American Hakko Products, Inc.

# PRODUCT BULLETIN

**Bulletin No:** PB430  
**Issue Date:** 2-19-2019  
**Effective Date:** 2-19-2019

**Description/Title:**  
Specification Change on DPF-200 Depaneling System

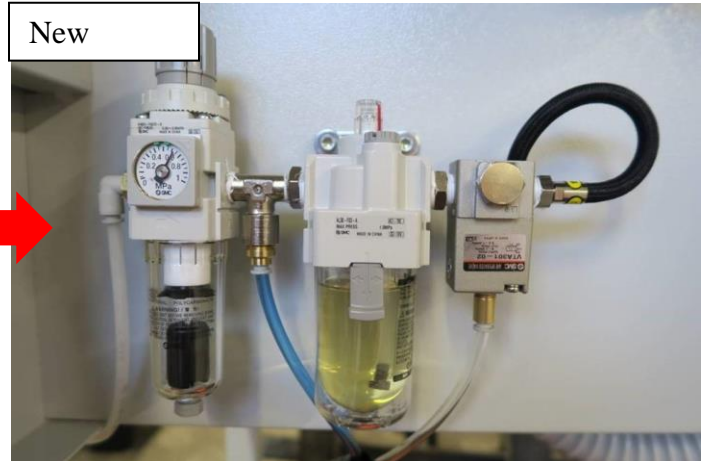
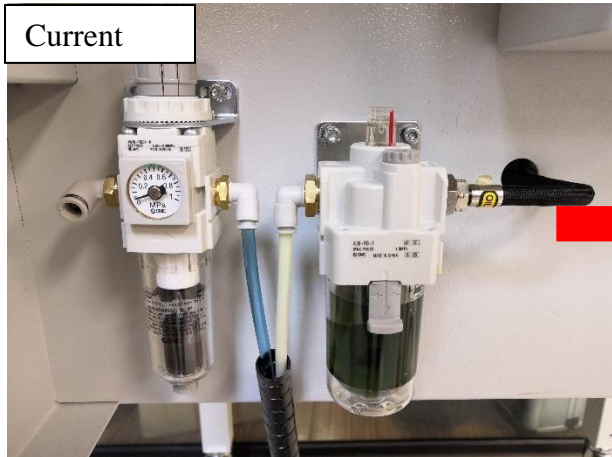
Starting from serial number 00000604, the DPF-200 depaneling system will come equipped with an improved air regulating and lubricating system. The new system is designed to further control the lubrication oil feed rate even under heavy usage. This change will not affect the performance and other specification of DPF-200.
